Addendum # 3
Bid Opportunity: 26-7849-RFT
Galt Collegiate Institute
Exterior/ Interior Upgrades to Tassie Hall
Closing Date: Wednesday, March 11, 2026 2:00 PM

Galt Collegiate Institute
EXTERIOR INTERIOR UPGRADES TO TASSIE HALL

This addendum, prepared by MTE Consultants, forms part of the contract documents, and modifies the original specifications and drawings as follows.

A6.01R

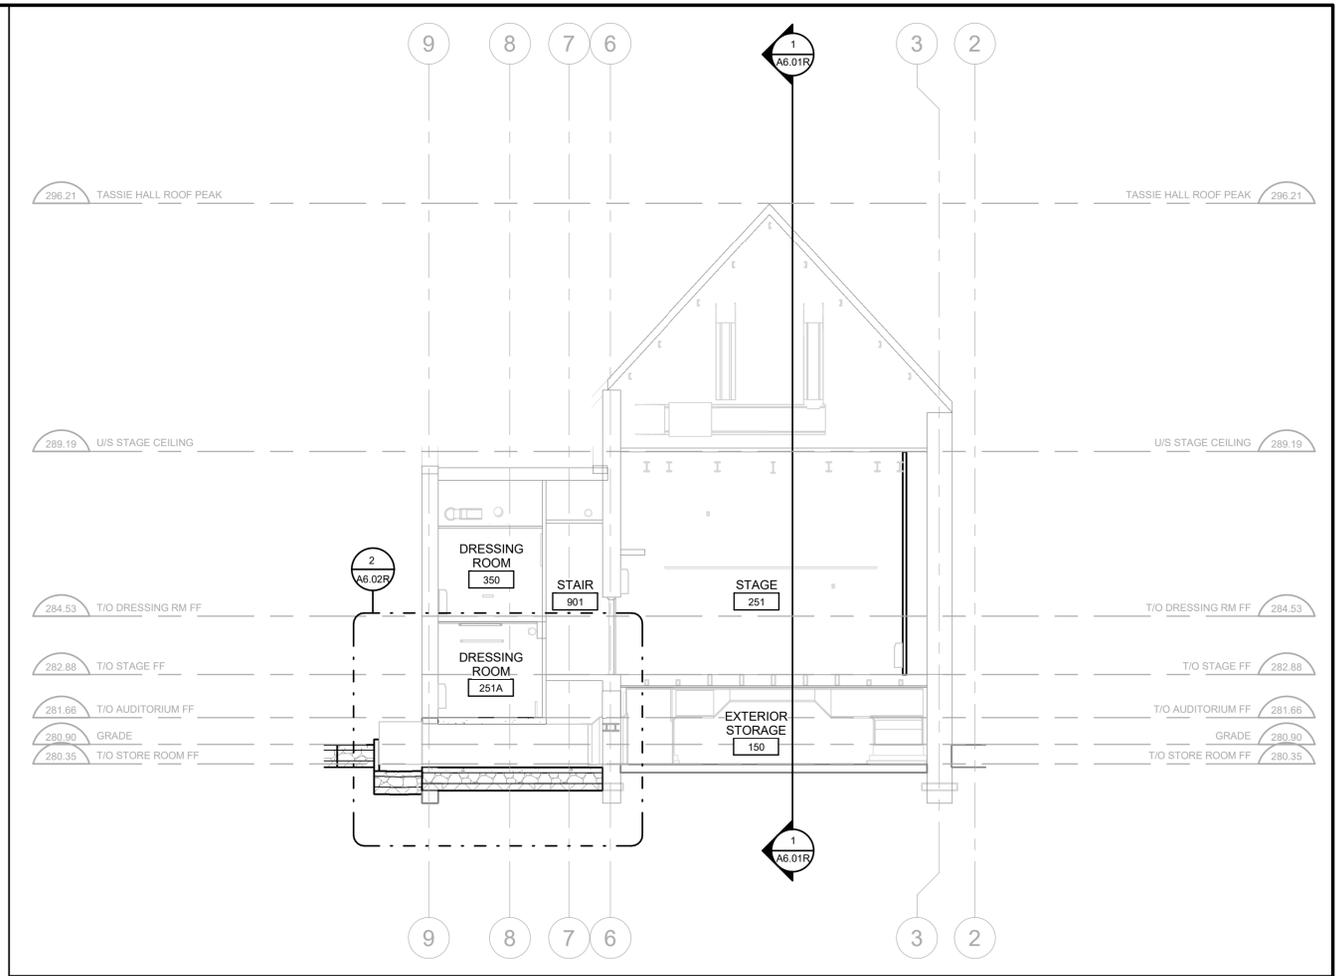
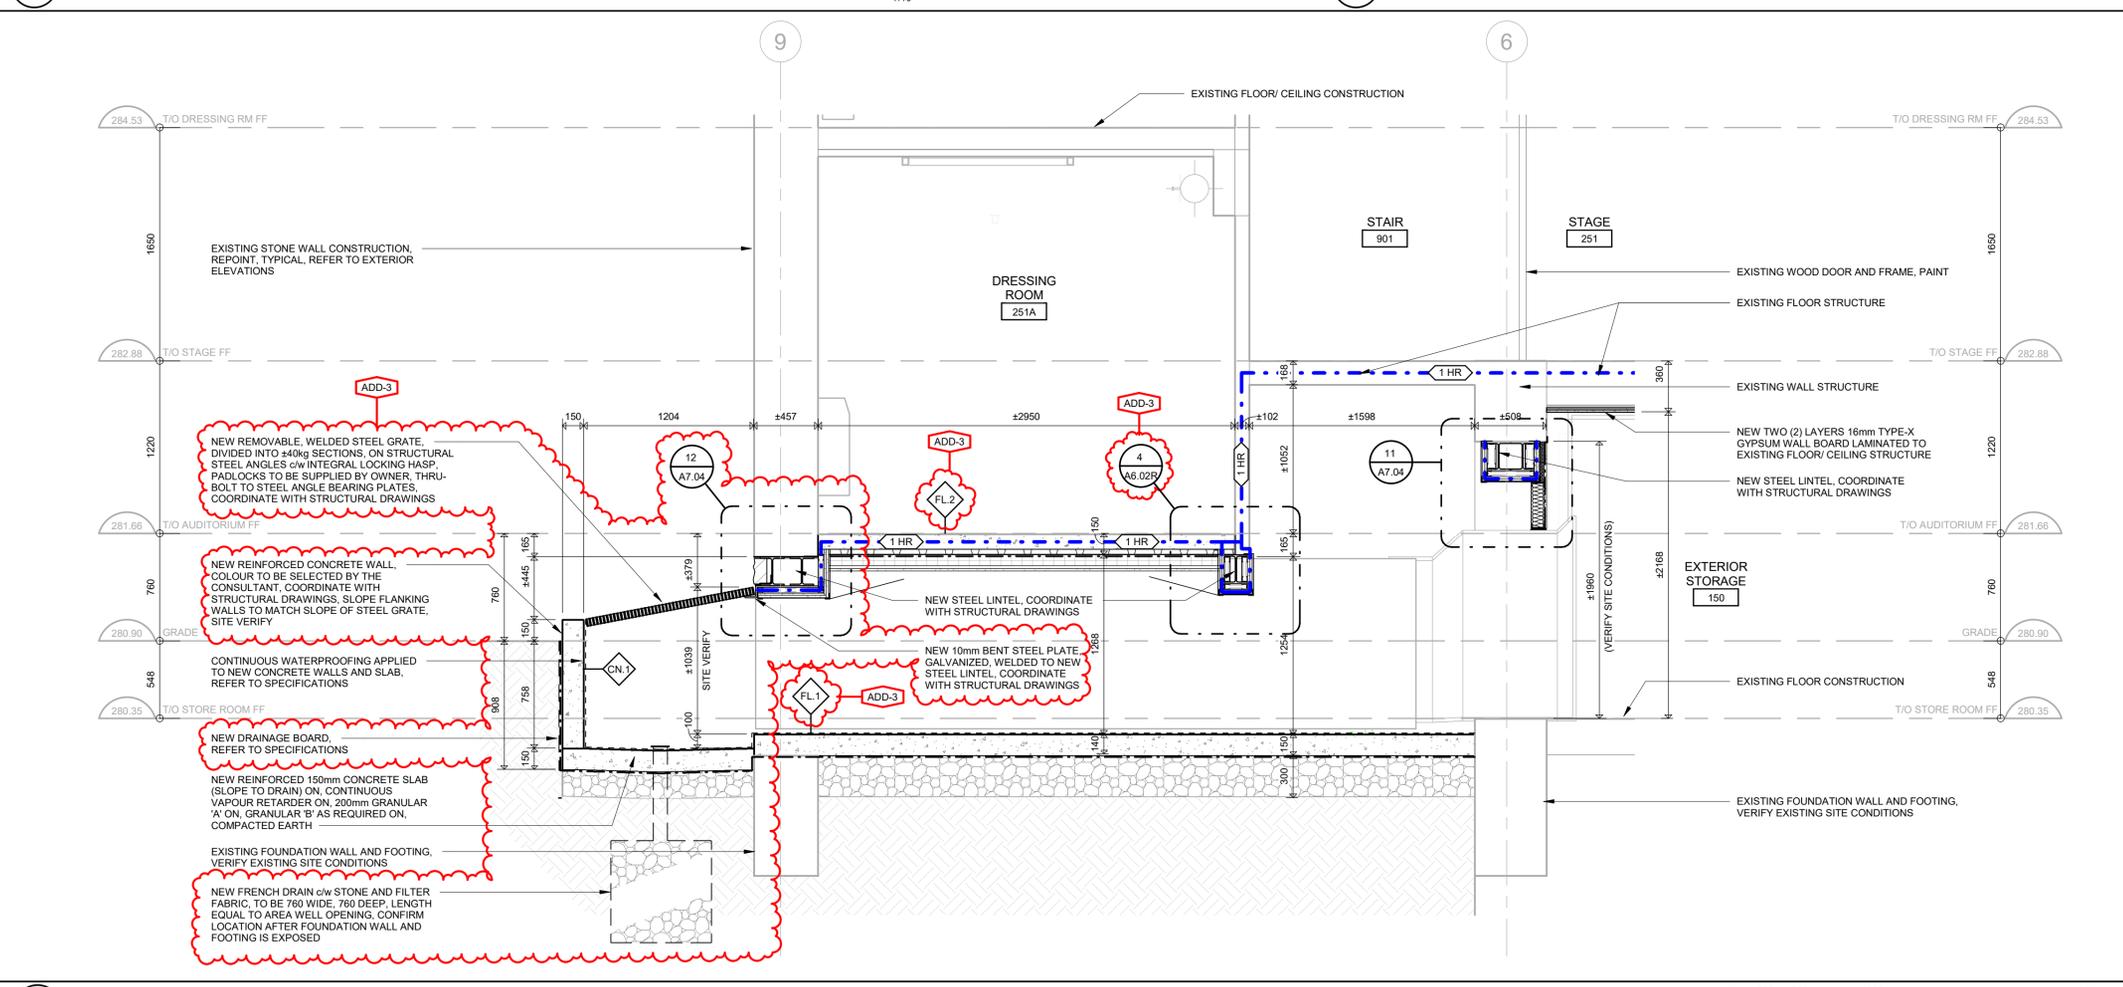
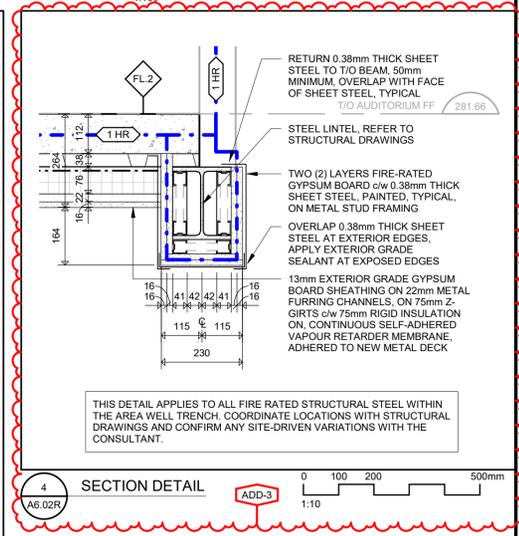
Are we removing the dressing room floor in its entirety? Drawing A6.02 has it looking like the floor structure is new. Plus it looks like the tags are to be reversed

Only the floor area over the new areaway is required to be removed. Refer to Item 3.3.4 below for clarification of Floor Type tags.

FRAMING PLANS
 S2.02

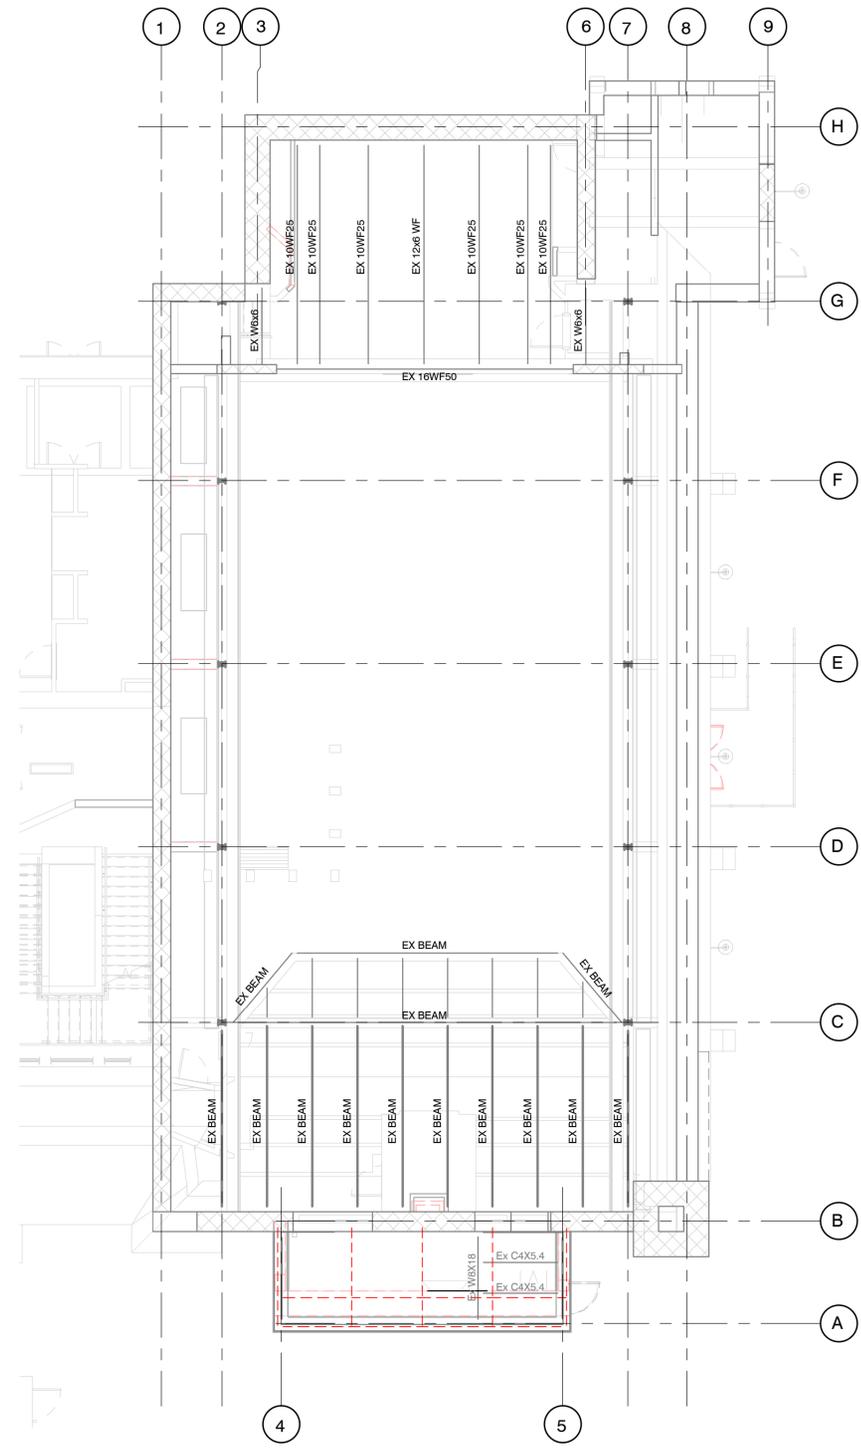
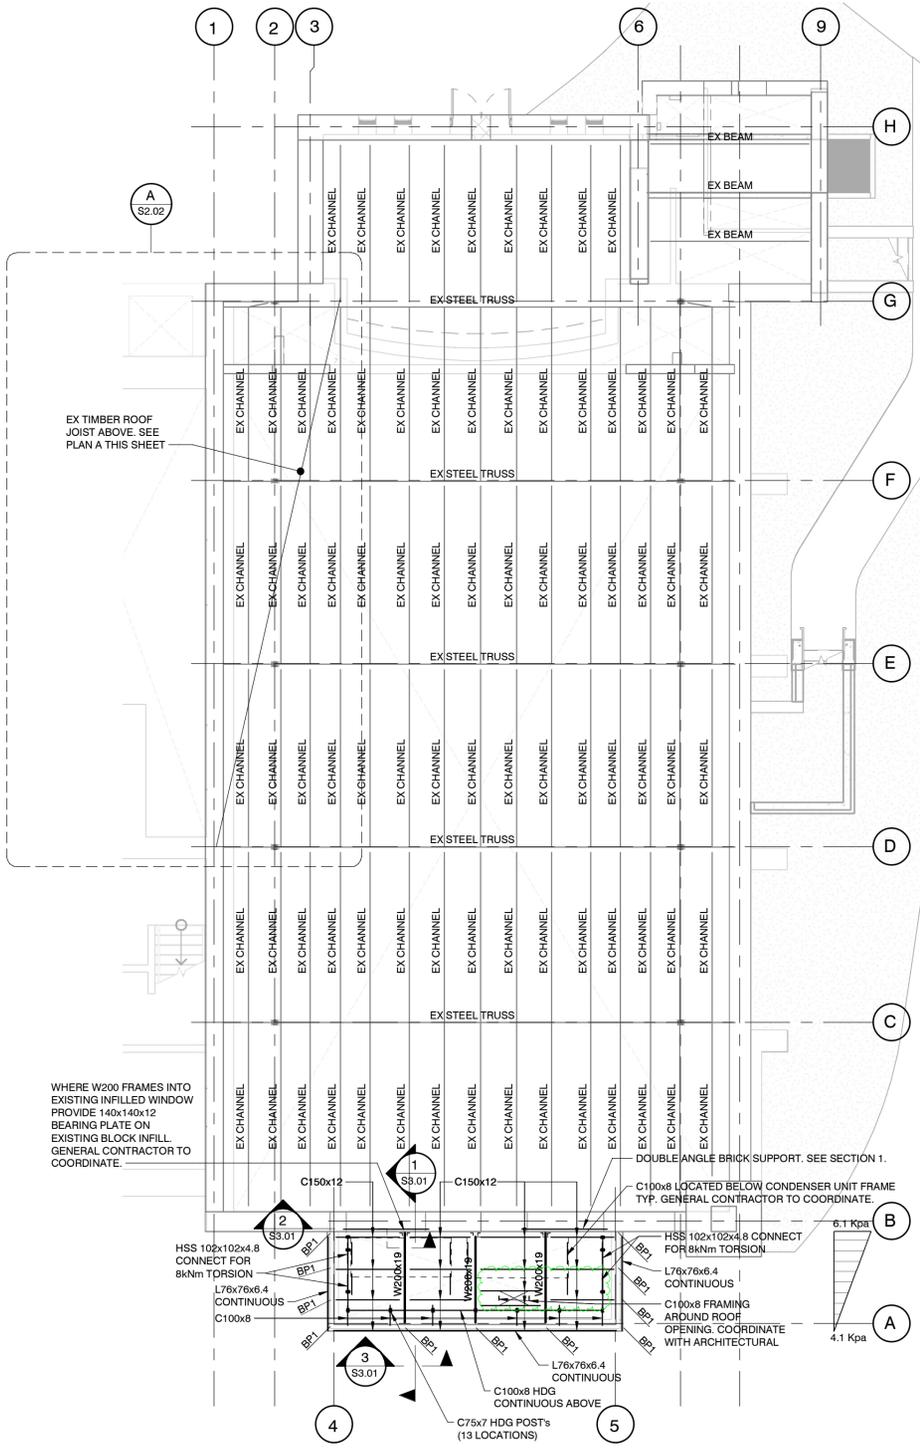
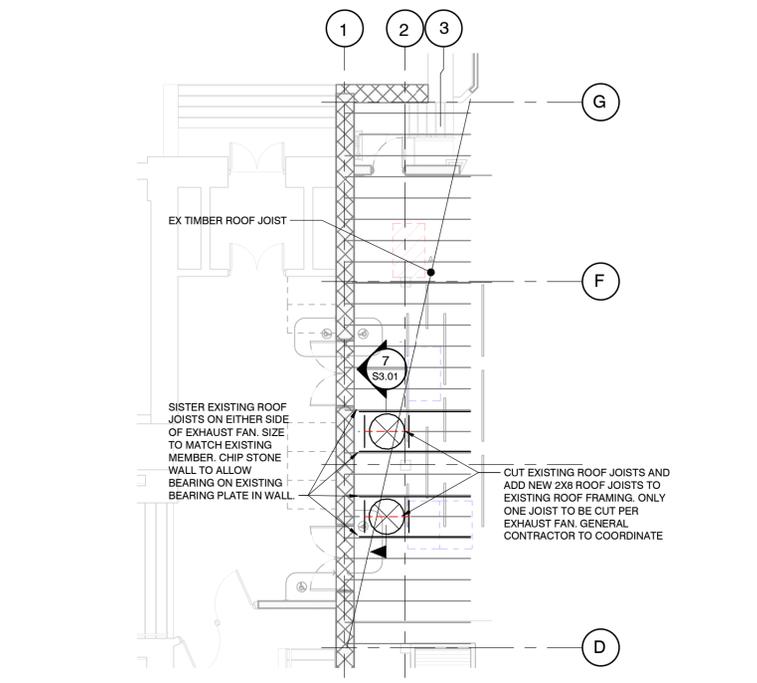
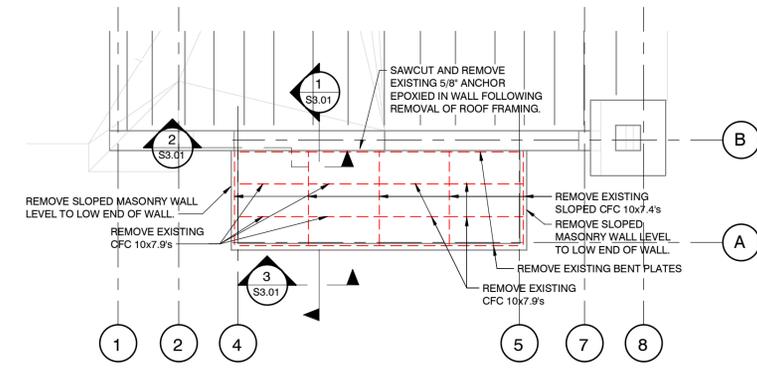
DRAWING S2.02

- a. Framing Plans
 - i. Main roof access opening revised. Additional beam added.
